**BEFORE THE BOARD OF PATENT APPEALS
AND INTERFERENCES**

Application Number: 09/848,583
Filing Date: May 03, 2001
Appellant(s): MATTHES ET AL.

EXAMINER'S ANSWER

Fig.1

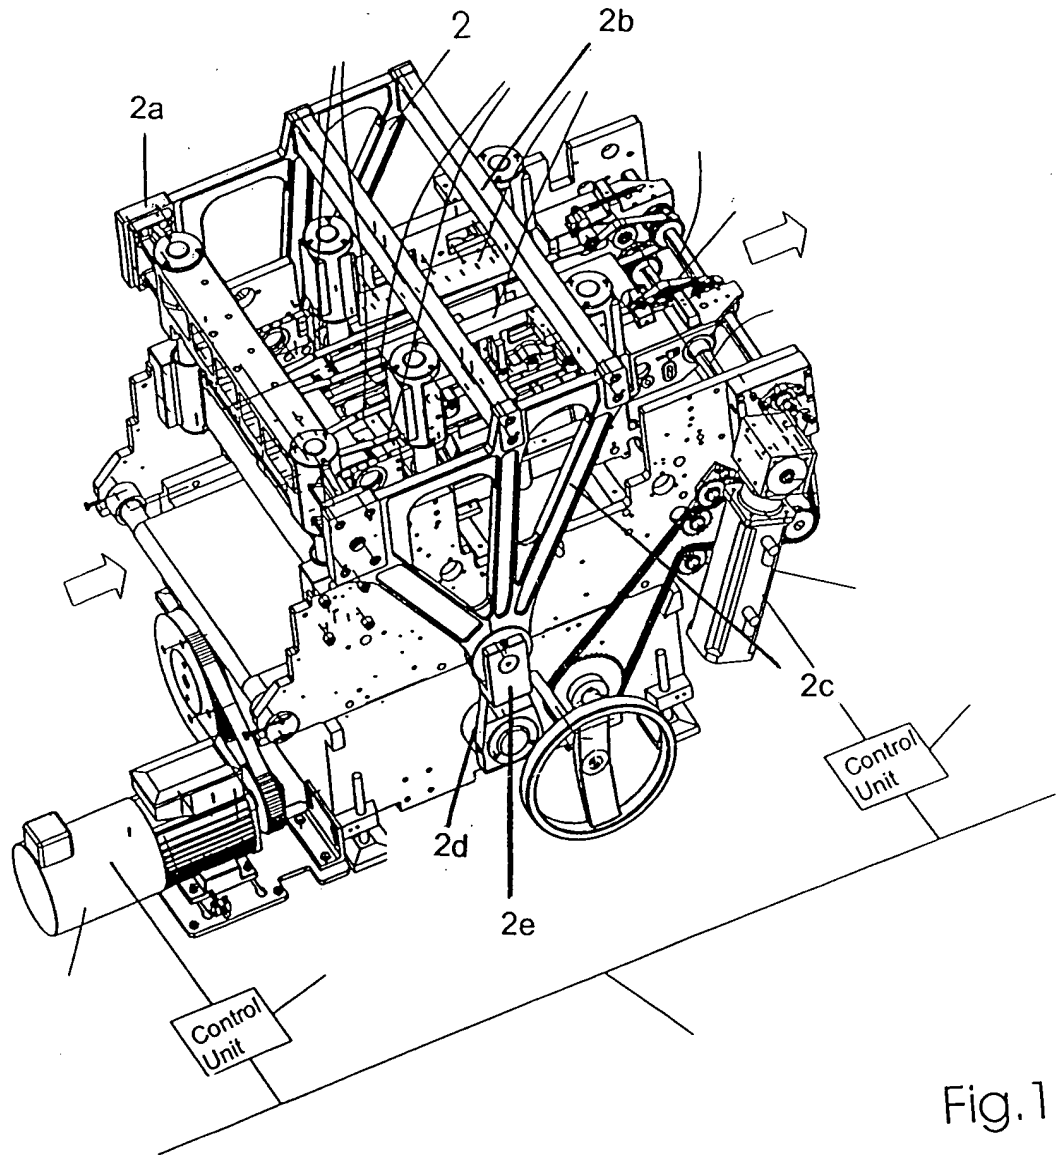
In regards to claim 1, it is unclear how the lifting device 2 uses the vertical, non-harmonic oscillatory motion to press knives 3 against the knife 13. It is uncertain if the whole lifting mechanism 2 moves up and down to move the knives 3 towards knife 13 or if the lifting mechanism pivots about the screw (Figure 2) and during this pivot the blades are dropped down to cut the work piece. Also, it is not clear what type of cutting is taking place. It is uncertain if knife 13 is a stationary blade to create a shearing cut with knives 3 or blade 13 acts as an anvil and knives 3 perform a punching/stamping cut. The functional language provided is not supported with any structure shown in the Figures or any structural language explaining how the lift mechanism moves knives 3 towards knife 13 to create the cutting action. It is unclear how a vertical, non-harmonic oscillatory motion is created and how the knife-lifting device (2 and 2a-2e) can move when it is fixed to the transmission at 2d.

Appellants contend that the use of the motor (1) with the belt (23), pulley (21), and transmission (22) achieves vertical, non-harmonic oscillatory motion of the knife-lifting device (2). The examiner strongly disagrees. Using Figure 1 on page 7 of this examiner's answer (and the added reference numbers 2a-2e), the knife-lifting device is considered to include all of the portions so labeled (All other reference numbers have been removed for clarity). Appellants have not provided support or a detailed

description of the knife-lifting device. As items 2 and 2a-2e appear, from the Figure, to be one piece or bolted together, it can only be interpreted by one of ordinary skill in the art that the knife-lifting device refers to this entire object, in that appellants' reference number 2 must reference all of the object including reference numerals 2a-2e added in the attached figure by the examiner. It cannot be determined how the transmission moves the knife-lifting device in a vertical, non-harmonic oscillatory motion. It is not supported by the specification and it is not shown in the Figures how the transmission and the knife-lifting device interact with one another to create the motion. In addition, it is unclear how the knife-lifting device (2 and 2a-2e) moves in a vertical direction. The knife-lifting device is connected to the transmission at 2d but in order for the knife-lifting device to be able to move in a vertical motion relative to the transmission there would have to be structure allowing 2d to move vertically within the transmission's casing. The knife-lifting device appears to be permanently fixed to the transmission at 2d, thereby restricting any movement at all. In order for the knife-lifting device to obtain vertical, non-harmonic oscillatory motion, the knife-lifting device (2 and 2a-2e) must somehow move, as a whole, vertically, in relation to the transmission.

harmonic. A non-harmonic motion would be, in this case, a non-continuous vertical motion. It is unclear how the transmission would allow the knife-lifting device to be a non-continuous motion. Also, one of ordinary skill in the art would not have the ability to know how this apparatus creates a non-harmonic motion without undue experimentation. In addition, it is unclear how the knife-lifting device (2 and 2a-2e) moves in the vertical, non-harmonic oscillatory motion relative to the transmission when part of the knife-lifting device is fixed to the transmission (2d).
